# HISTORIC AND DESIGN REVIEW COMMISSION

**HDRC CASE NO:** 2020-252  
**ADDRESS:** 328 E JOSEPHINE  
**LEGAL DESCRIPTION:** NCB 975 (BOEHLER'S SUBD), BLOCK 18 LOT 15  
**ZONING:** C-3, RIO-2  
**CITY COUNCIL DIST.:** 1  
**APPLICANT:** Kristen Weber/Don B. McDonald, Architect  
**OWNER:** RIO PERLA PROPERTIES LP  
**TYPE OF WORK:** Amendments to a previously approved design, new construction, site work  
**APPLICATION RECEIVED:** June 12, 2020  
**60-DAY REVIEW:** Not applicable due to City Council Emergency Orders  
**CASE MANAGER:** Edward Hall  
**REQUEST:**

The applicant is requesting a Certificate of Appropriateness for approval to amend a previously approved design. Within this request, the applicant has proposed the following:

### **Item 7: Brick Walk**

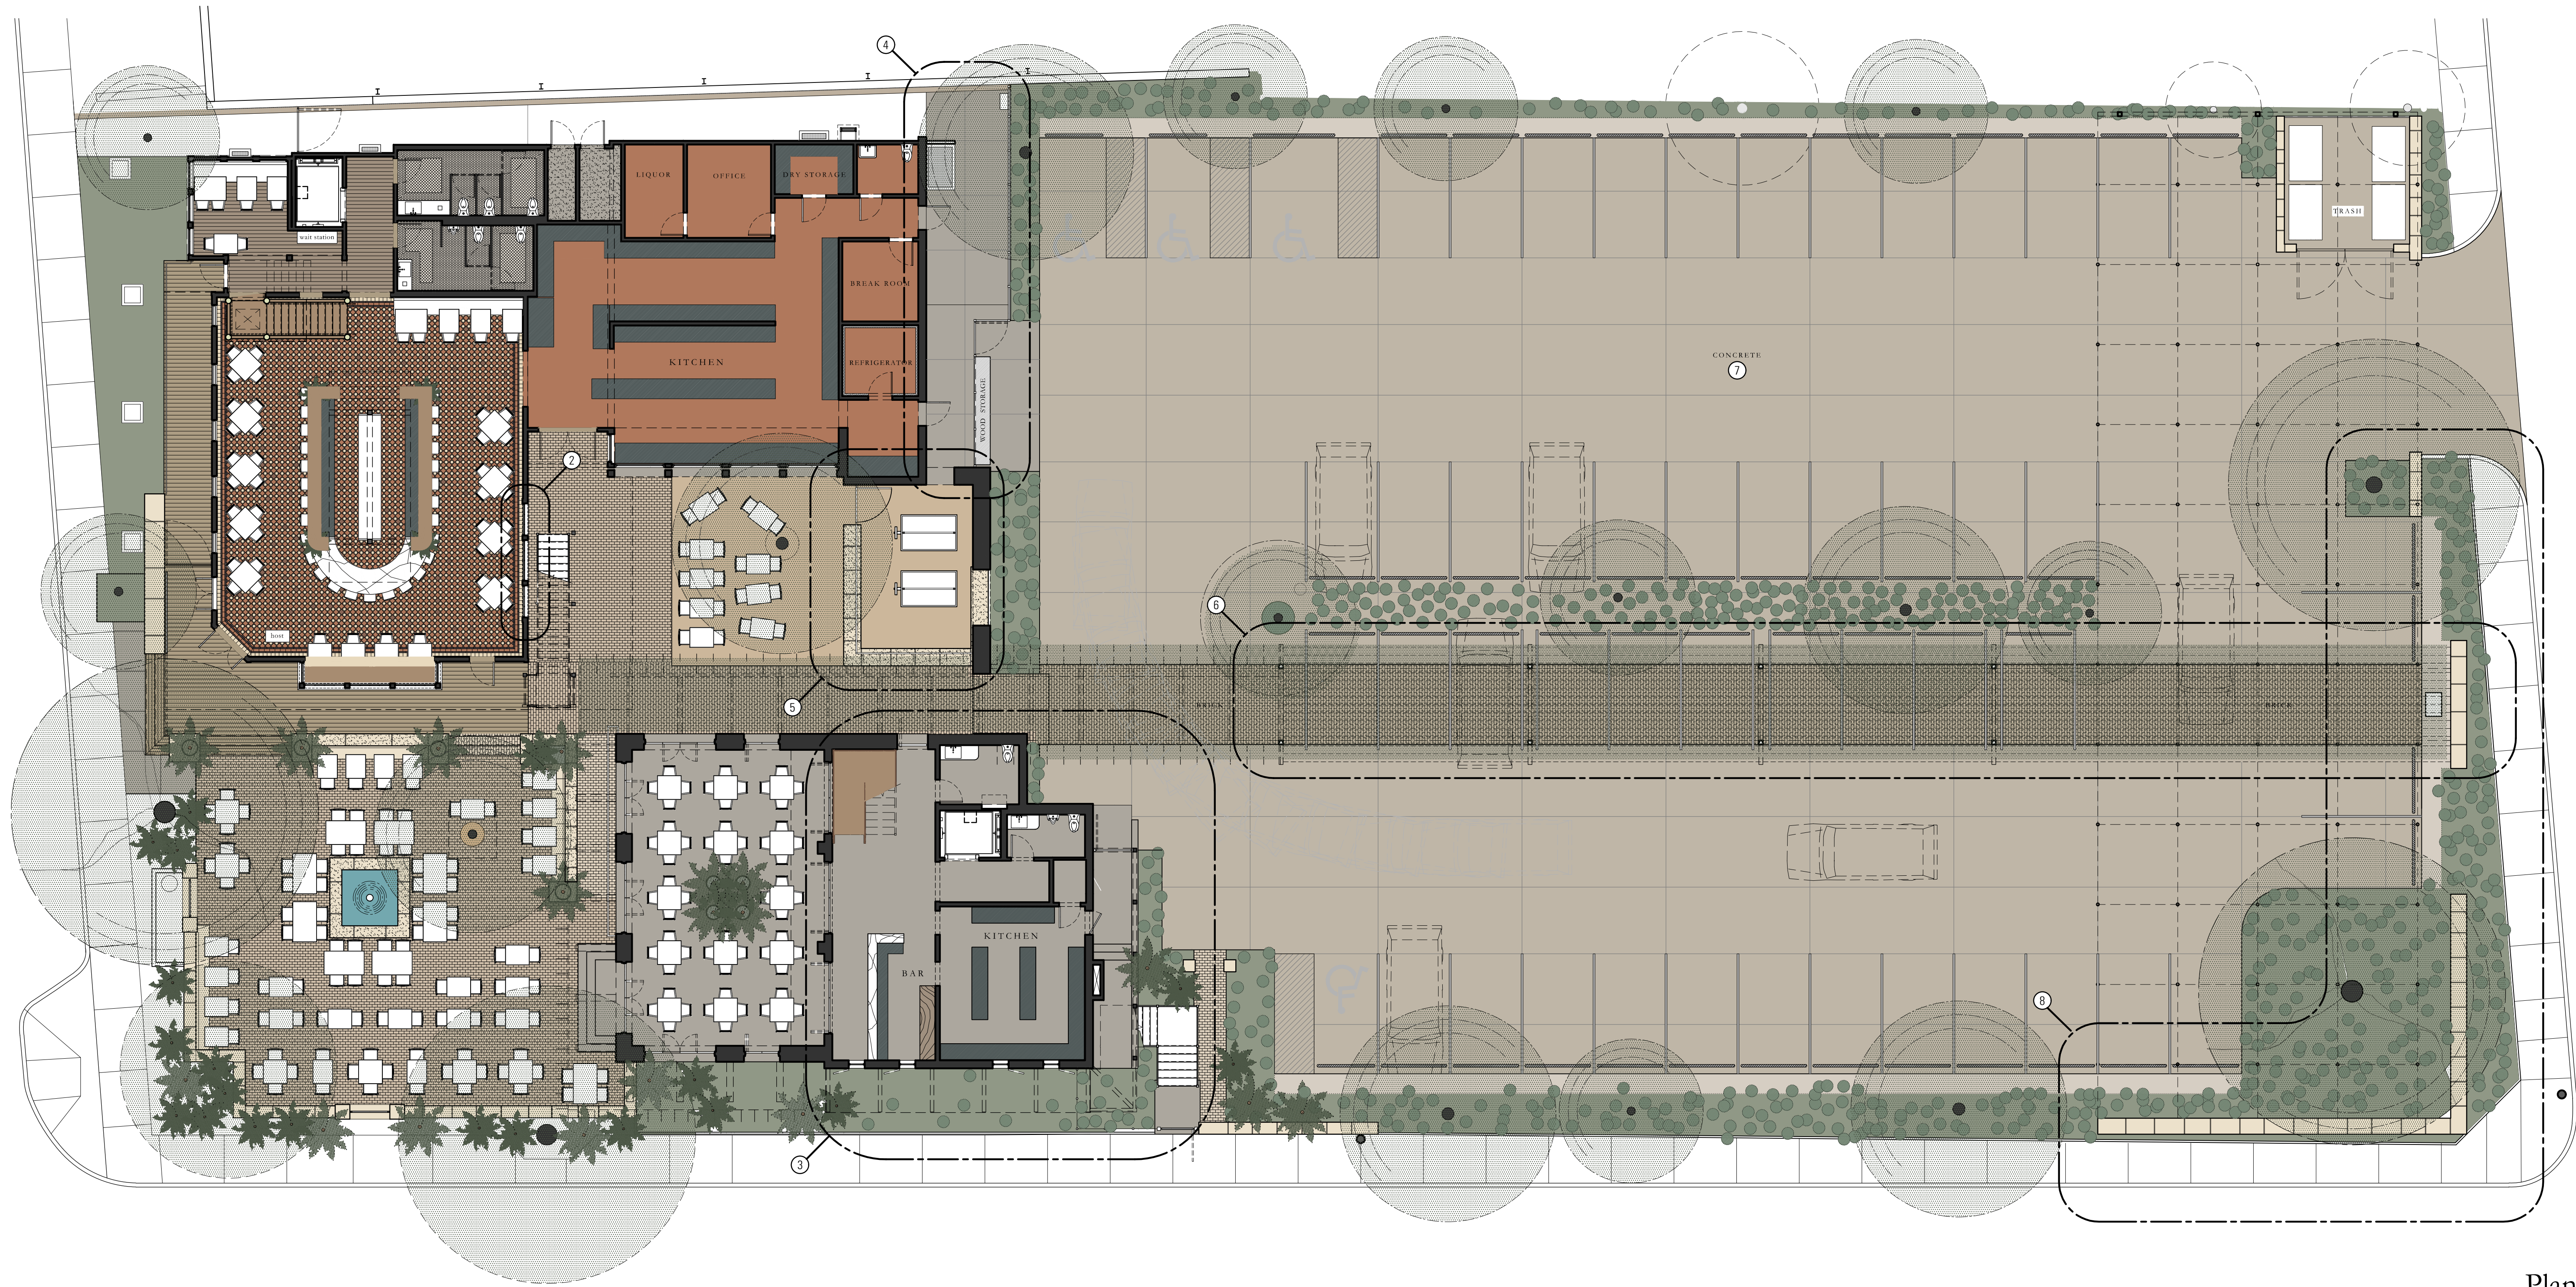
6. Extend the previously approved arbor structure the full length of the parking lot to Josephine Street.
7. Construct a brick walk beneath the arbor structure and adjacent to the walkway to run from the Boehler's Bar north across the concrete parking lot to Josephine Street.

A brick walk is proposed beneath the Arbor. The walk runs from the Boehler's Bar Building, north across the concrete Parking Lot to Josephine Street.

# Boehler's Bar Clerestory Revision

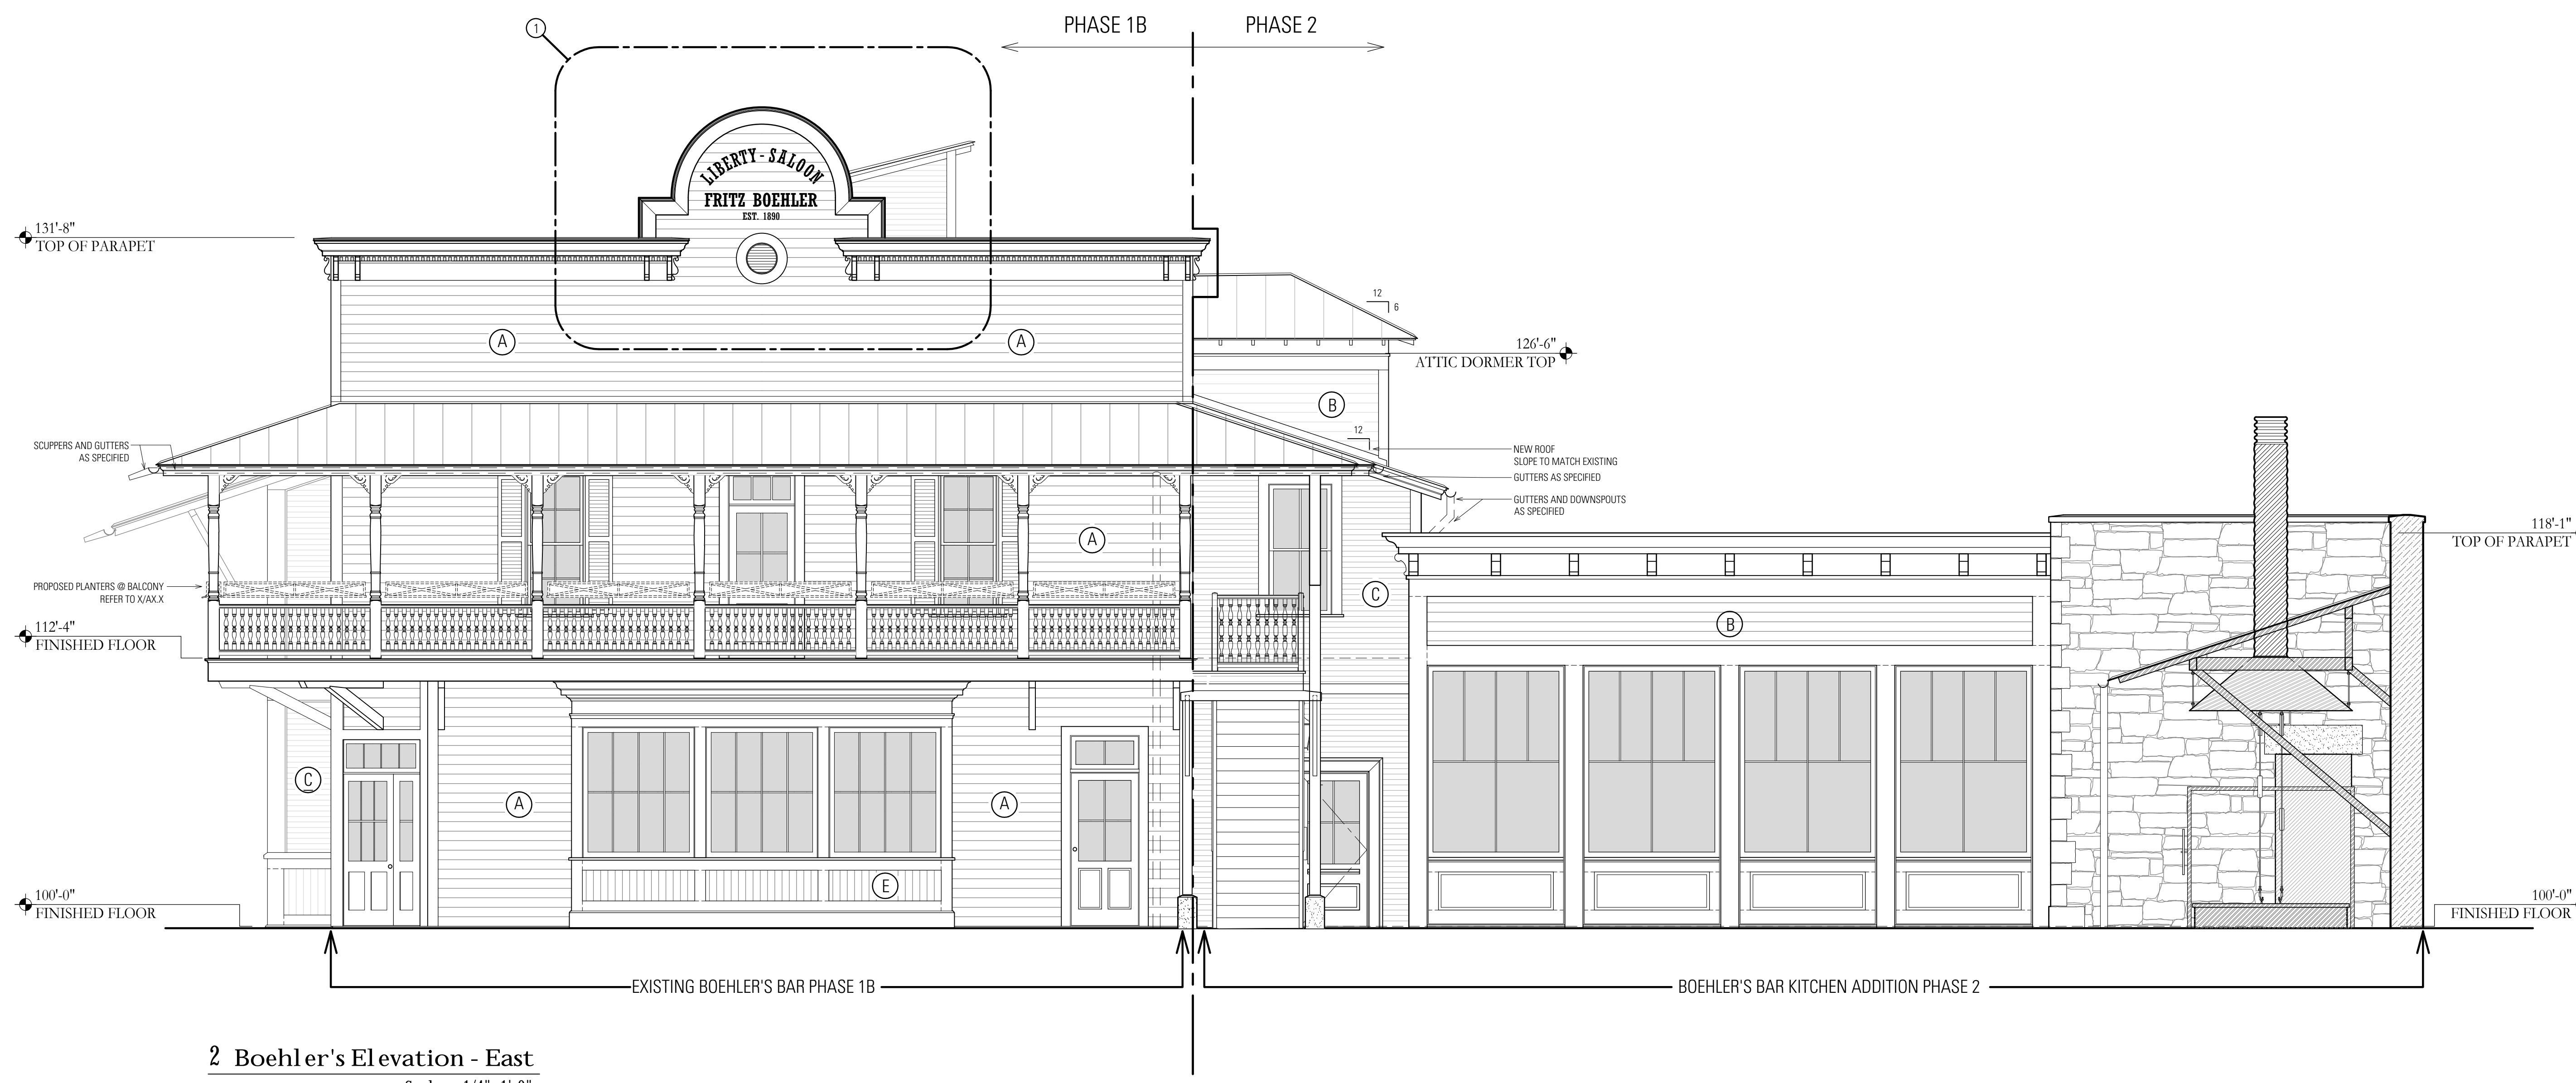
1. Eliminate the south facing clerestory window and install a north facing clerestory window on the Boehler's Bar structure.
2. Add three, north facing window to the Boehler's Bar structure.

- b. CLERESTORY WINDOW – The applicant has proposed to eliminate the previously approved south facing clerestory window and construct a north facing clerestory window. This design amendment is not proposed on a primary façade, and staff finds it to be appropriate. The proposed windows should be consistent with those existing on the structure in regards to their profile, materials and installation depth.

### **Item 1: Omit South Clerestory. Add North Clerestory.**

# Boehler's Bar North Window Addition

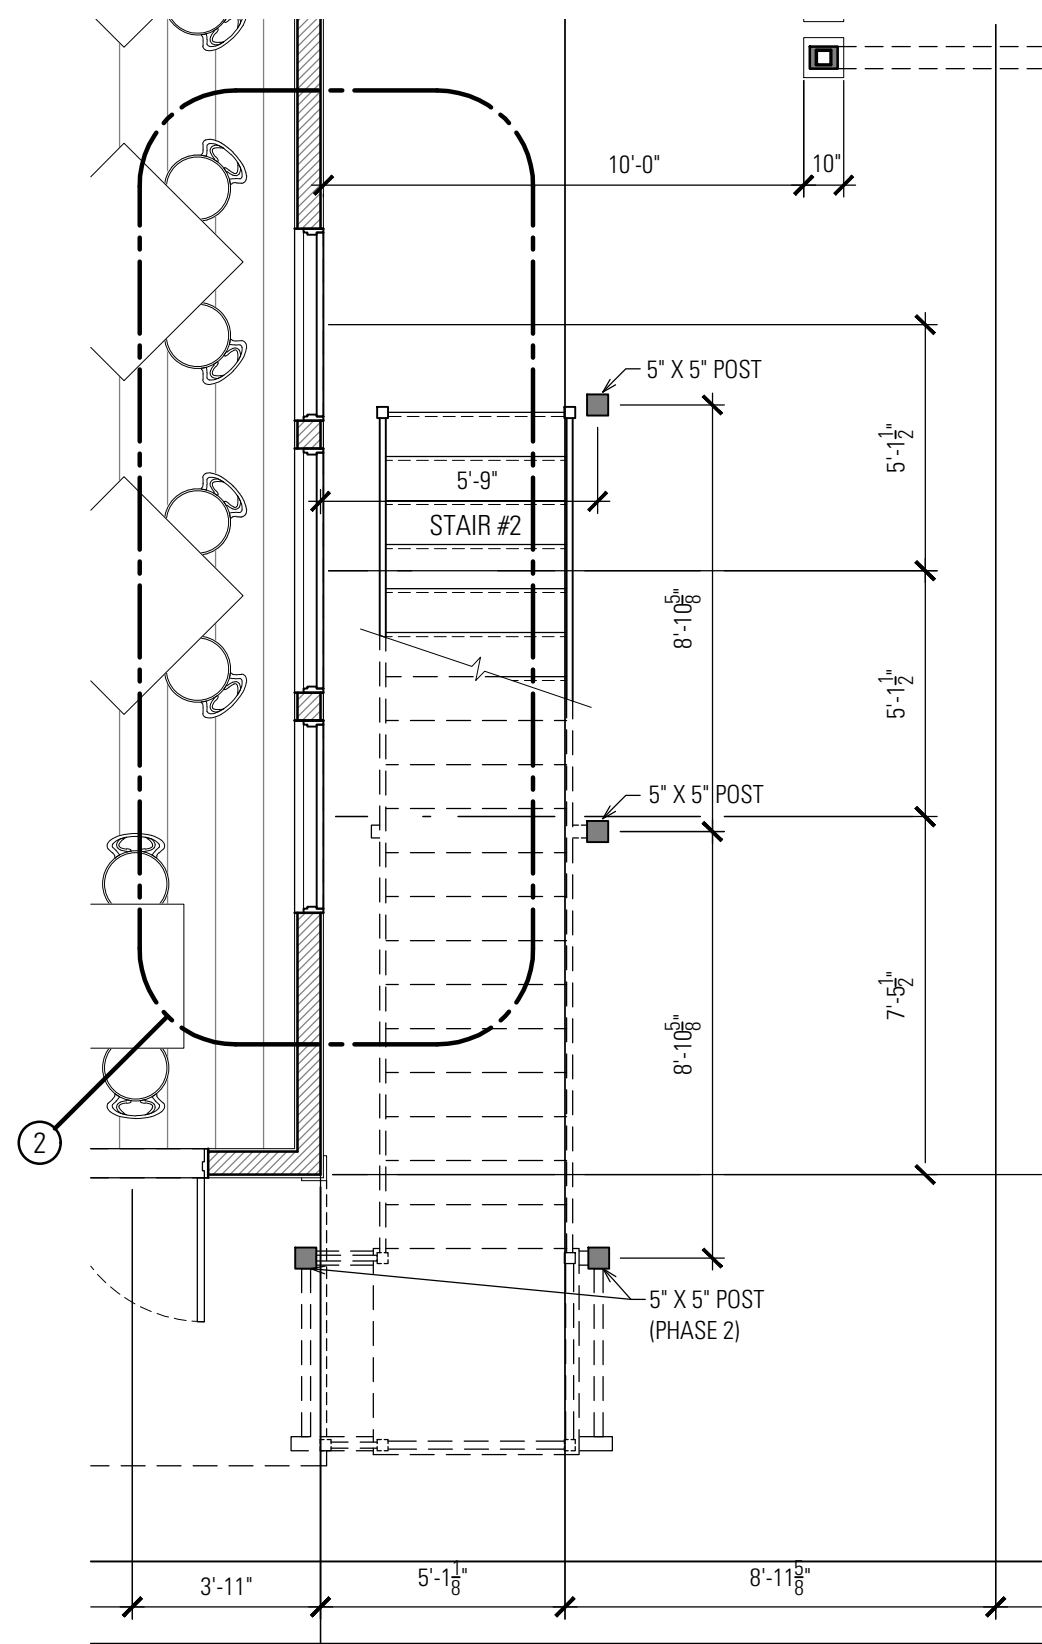
### **Item 2: Add North Window to Boehler's Bar Building**
